Final Report - Corrections Required **Application No. DEPN-26-0013**

Description : Development Plan to establish internal roadways and lots. No end-users are proposed with this development plan application.

RAY CHARLES COMMERCIAL CENTRE FILING NO.1 DEVELOPMENT PLAN

DEVELOPMENT PLAN
COVER

SHEET
1 OF 6

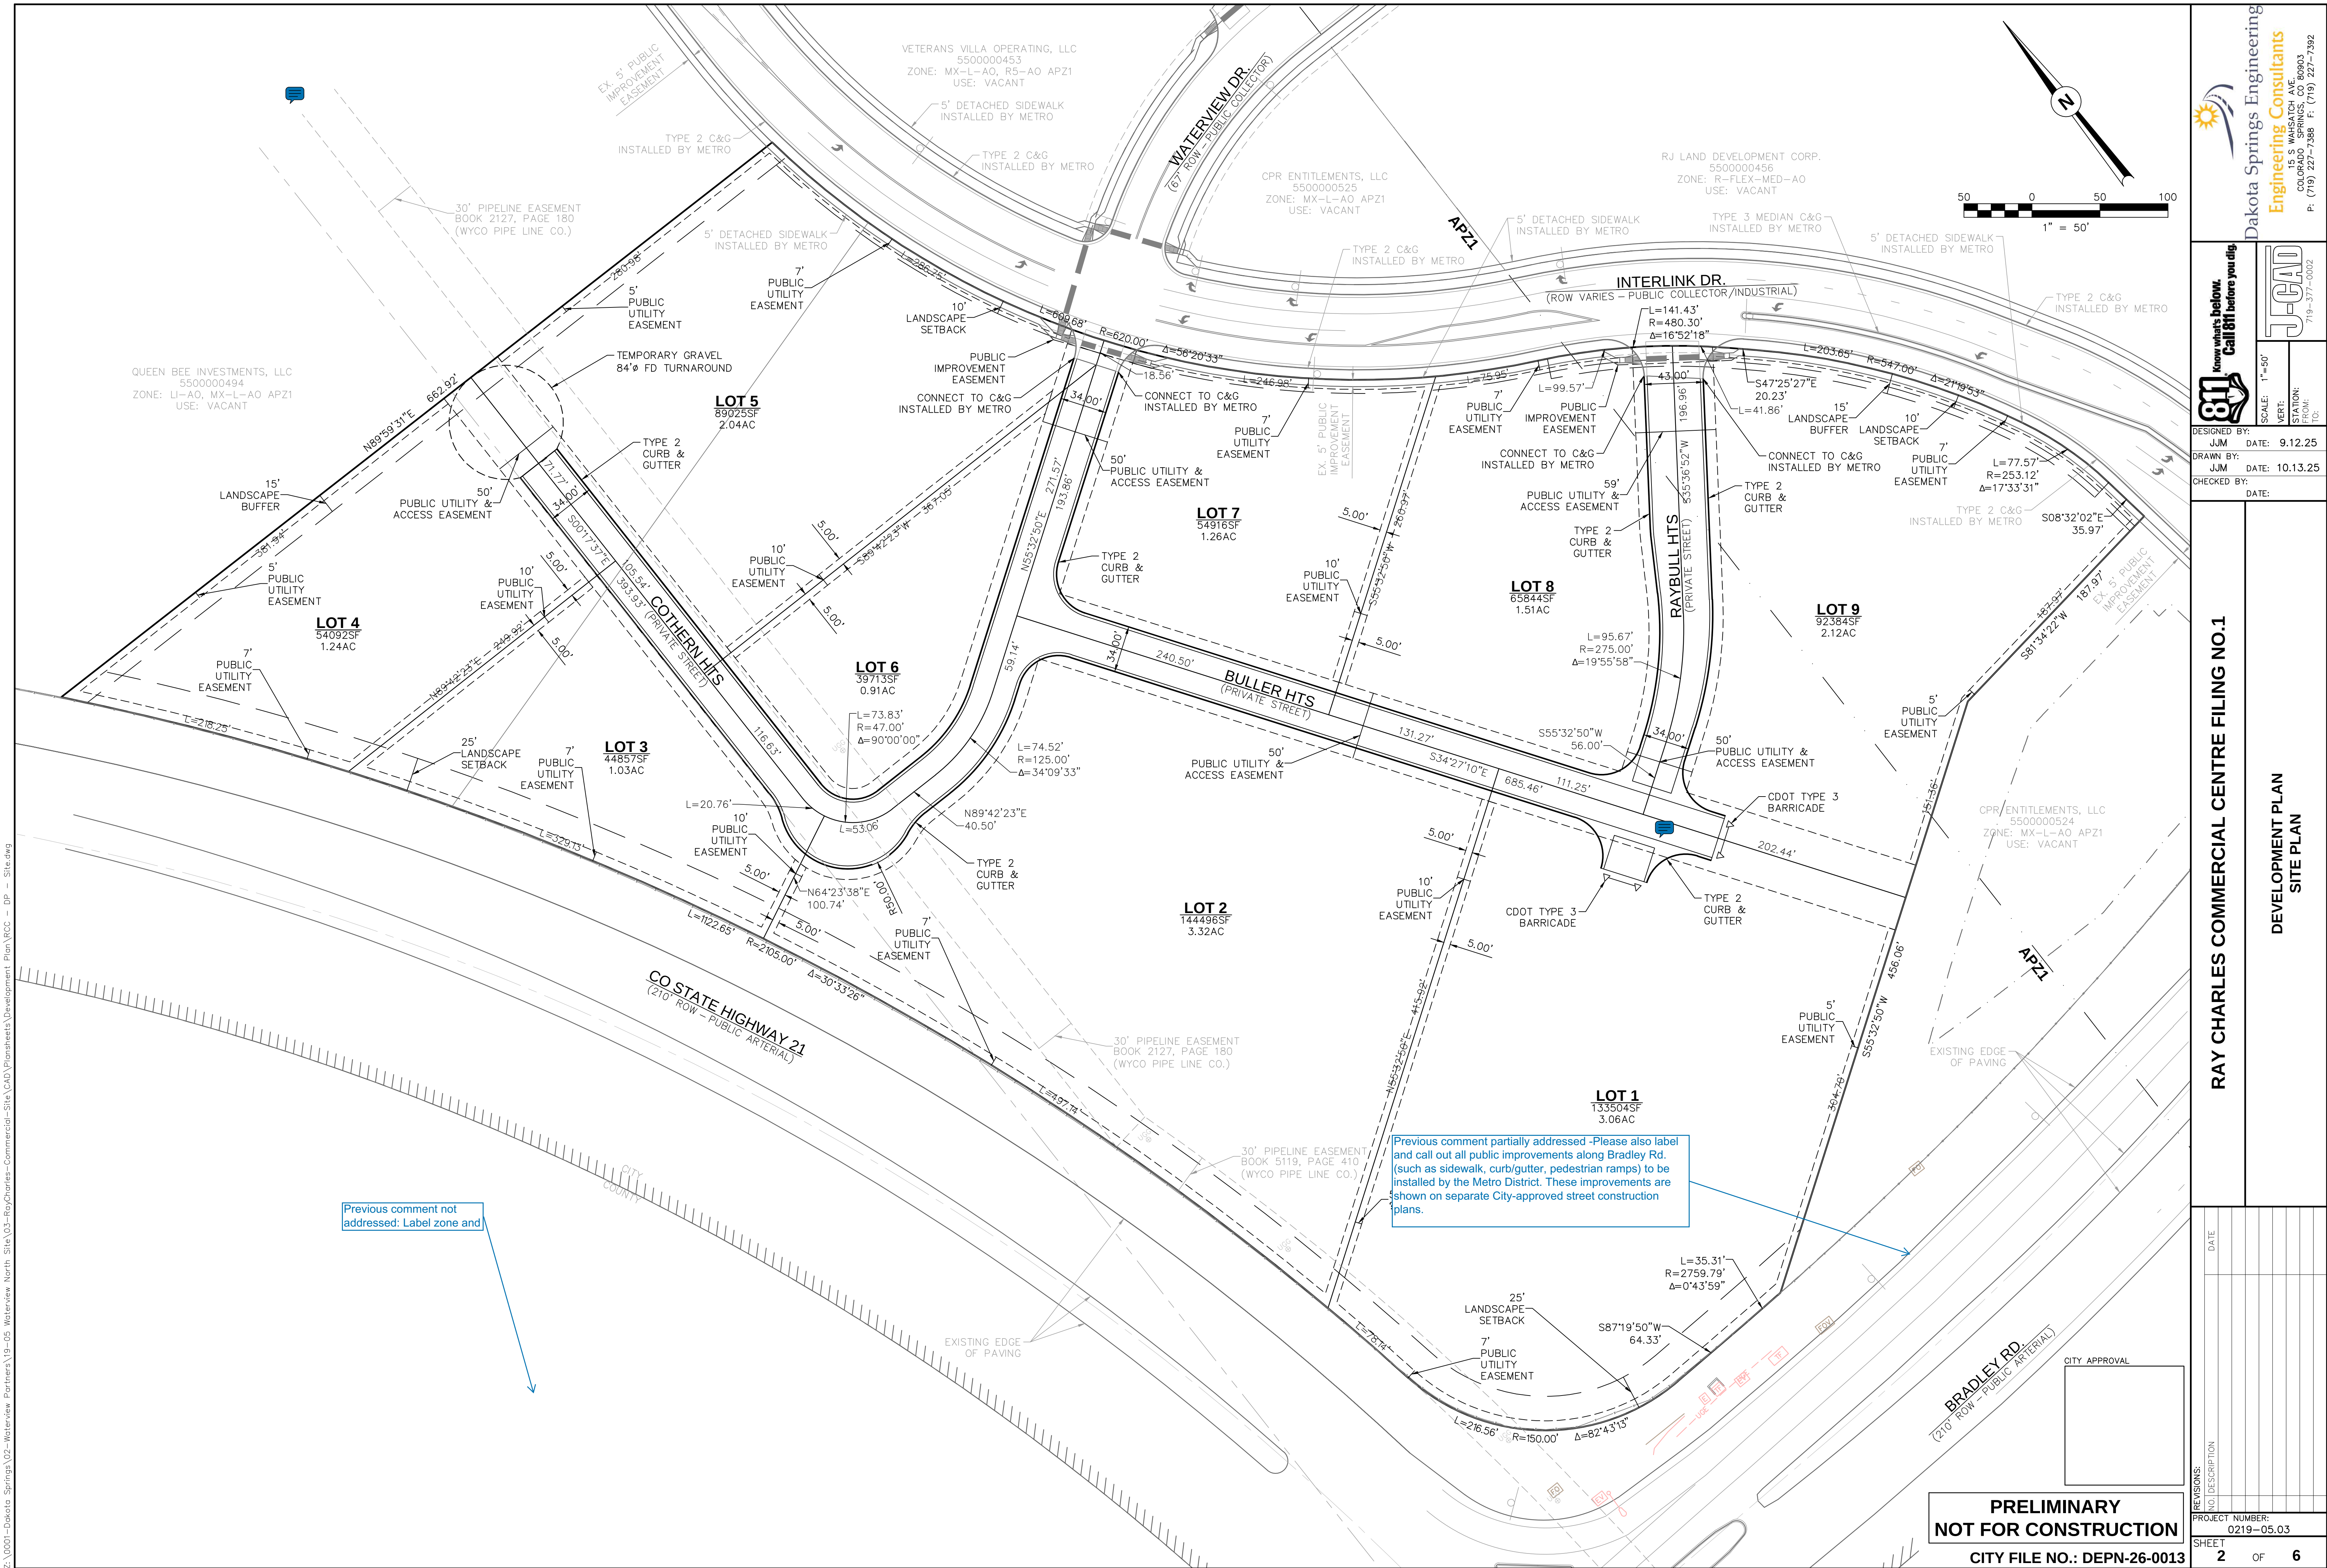
Please place all ADA standards in its own block.

Revise note 21: This is not a correct statement. There are several uses that are not permitted within the APZ-1 within the industrial/commercial land use categories.

Please remove Note 23

Revise: Future development of each lot shall be subject to additional development plan applications for review by City Planning.

Remove due to revisions to note 28.

All building setbacks are N/A for this zone district.

Revise the master and concept plan line items to include their titles: Title_File Number

SHEET
5 OF 6

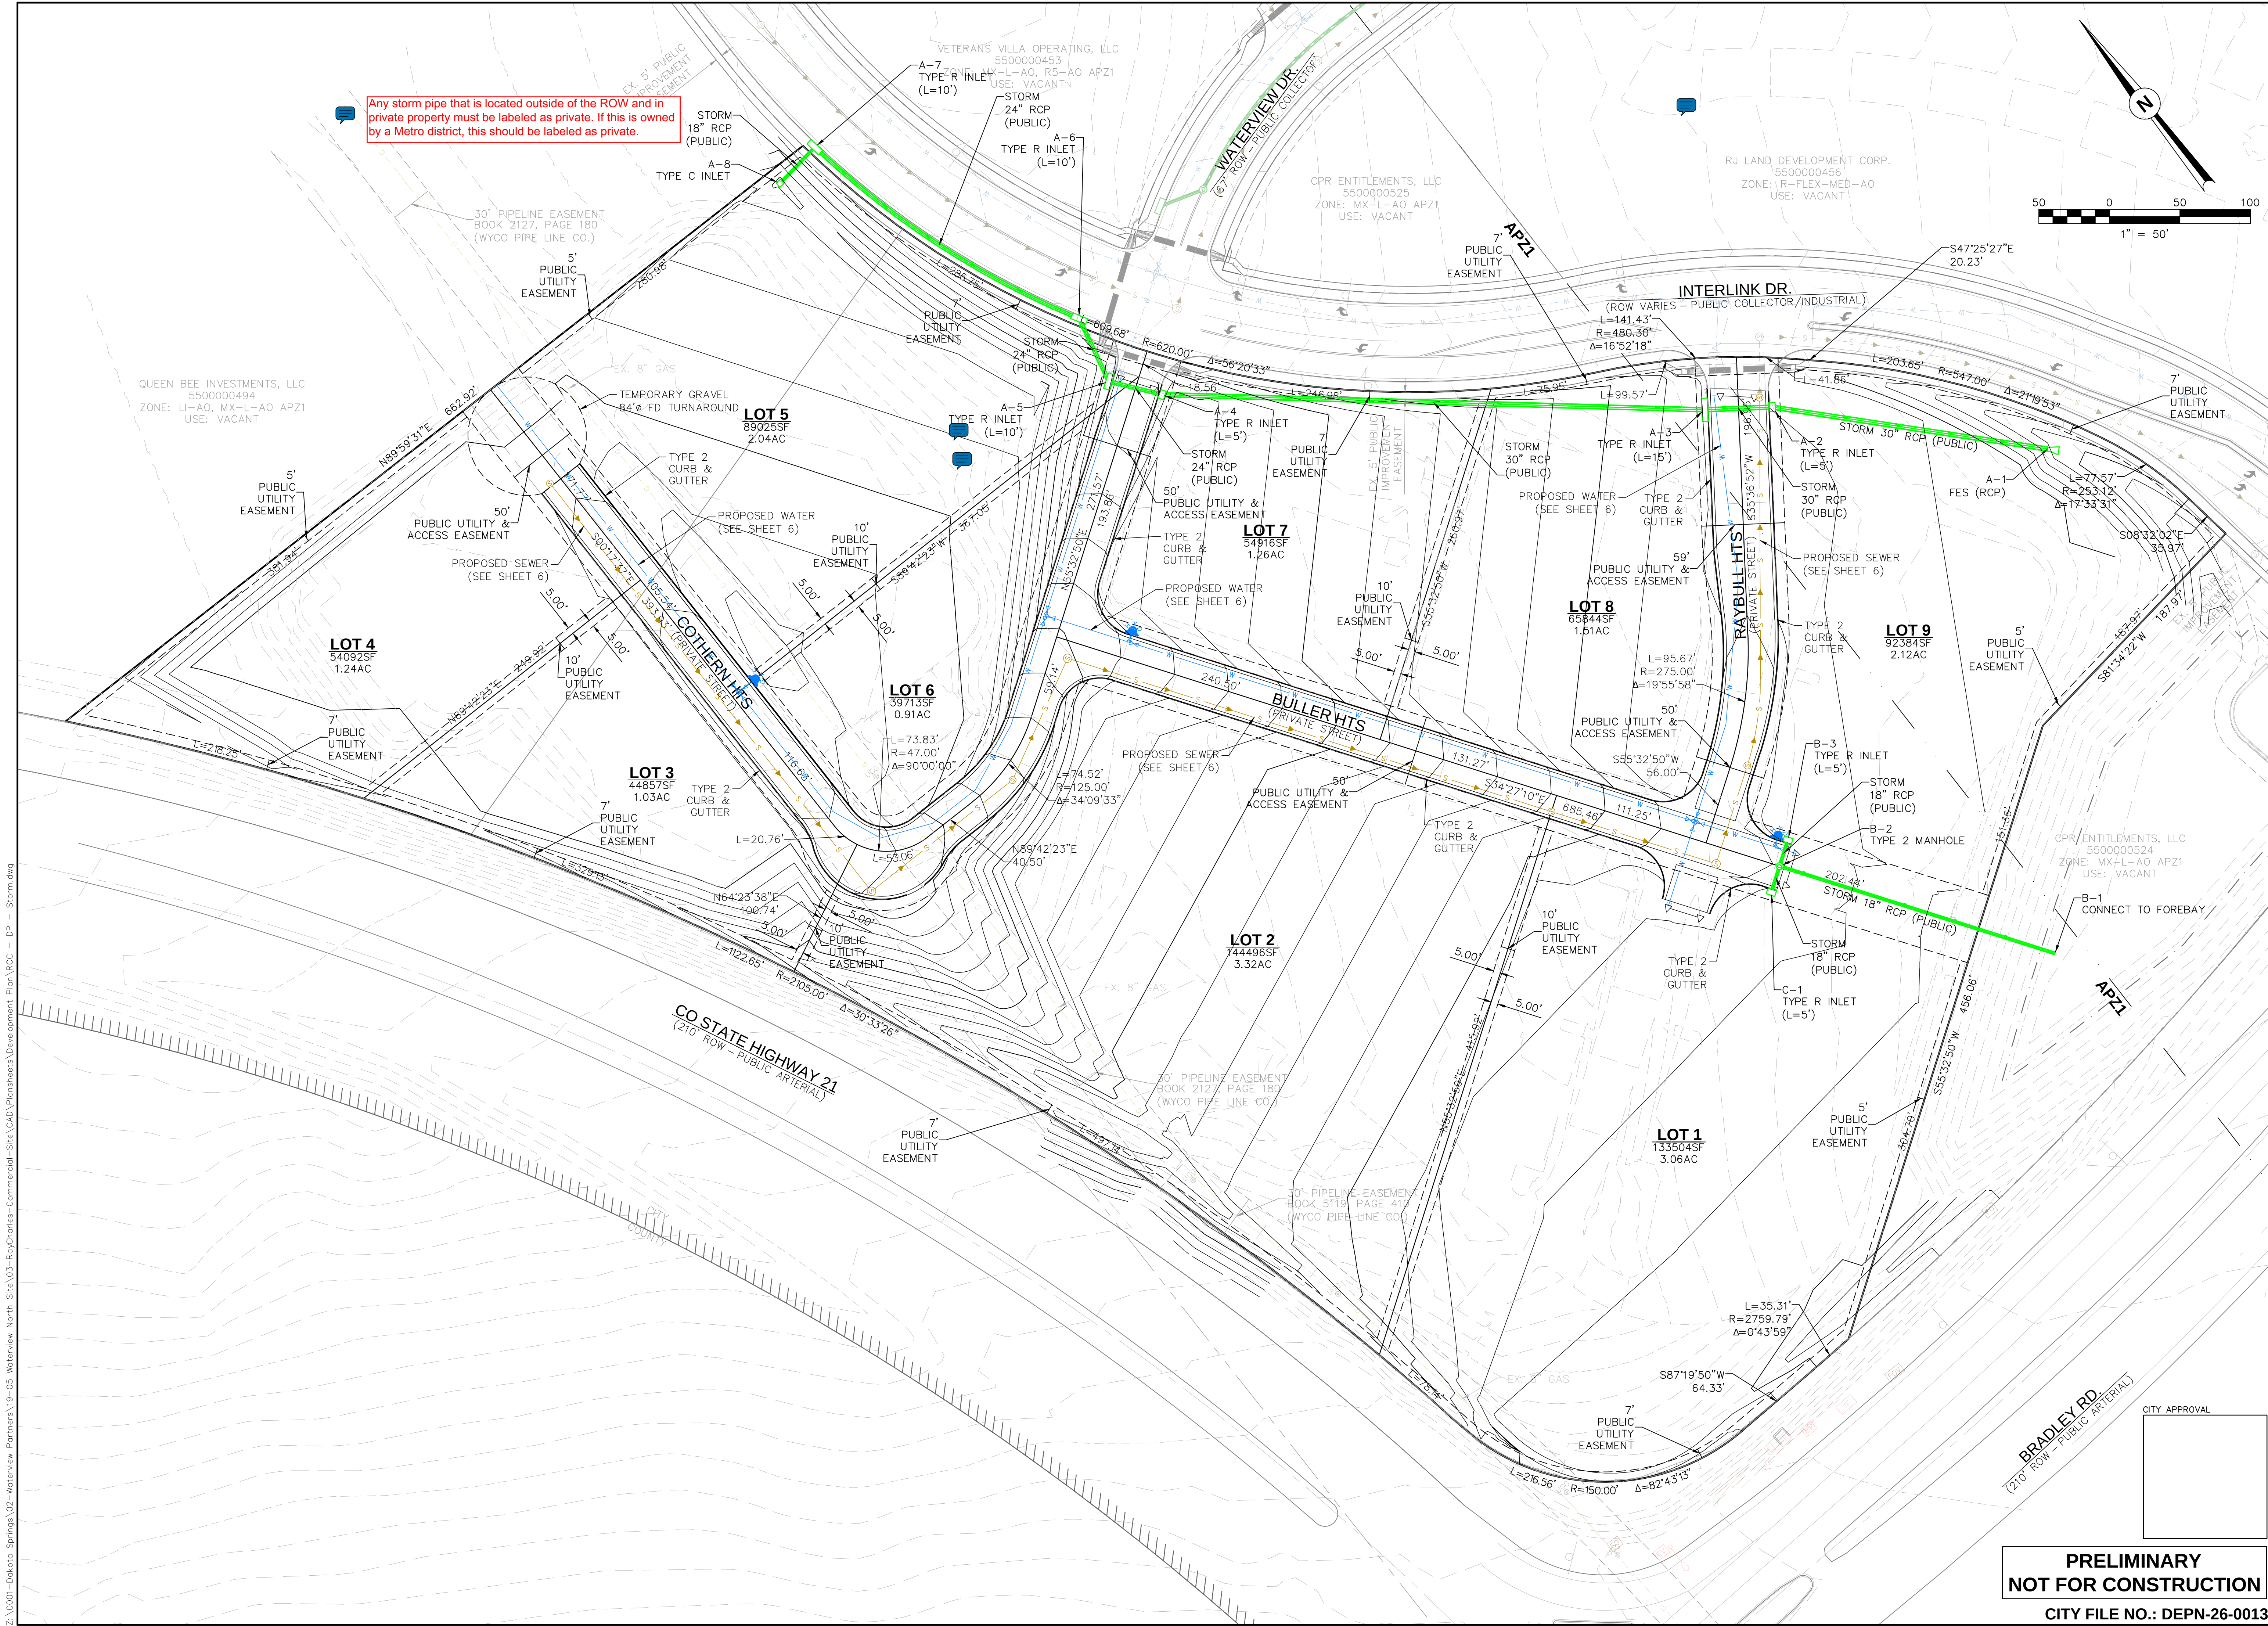
Comment ID	Page Reference	Reviewer : Department	Review Comments
42	5	Sara Rivera : City Engineering - SWENT	Info Only: The City of Colorado Springs (City) Public Works Department issued updated standard details for inlets on July 8th, 2024. The updated inlet details are available here: Link . All proposed inlets in the City of Colorado Springs must conform to these updated inlet details. Please note that these five (5) new City standard inlet types are similar to other previously acceptable inlet types, as can be seen in SWENT's May 2025 Policy Clarification, "Hydraulic Modeling for Colorado Springs Standard Inlets" available here: Link .
43	5	Sara Rivera : City Engineering - SWENT	All proposed inlets must meet one of the five (5) new / updated City standard inlet types. See related Info Only comment for more information.
45	5	Sara Rivera : City Engineering - SWENT	Label all existing and proposed drainage infrastructure with size and ownership (private or public).

47	5	Sara Rivera : City Engineering - SWENT	The offsite disturbance associated with utility installations must be included in the total disturbed area. In the FDR, areas of disturbance for offsite utility installation can be excluded from the total disturbed area as it applies to the Four Step Process, but this exclusion must be clearly documented. Please reach out to the Lead Reviewer if there are questions on how to show this. For the GEC and CWMP this disturbed area must be shown and included. This area cannot be excluded in these plans/reports.
69	5	Sara Rivera : City Engineering - SWENT	Any storm pipe that is located outside of the ROW and in private property must be labeled as private. If this is owned by a Metro district, this should be labeled as private.
73	1	Joel Dagnillo : City Engineering Dev Review	Please remove Note 23
72	2	Joel Dagnillo : City Engineering Dev Review	Previous comment partially addressed -Please also label and call out all public improvements along Bradley Rd. (such as sidewalk, curb/gutter, pedestrian ramps) to be installed by the Metro District. These improvements are shown on separate City-approved street construction plans.
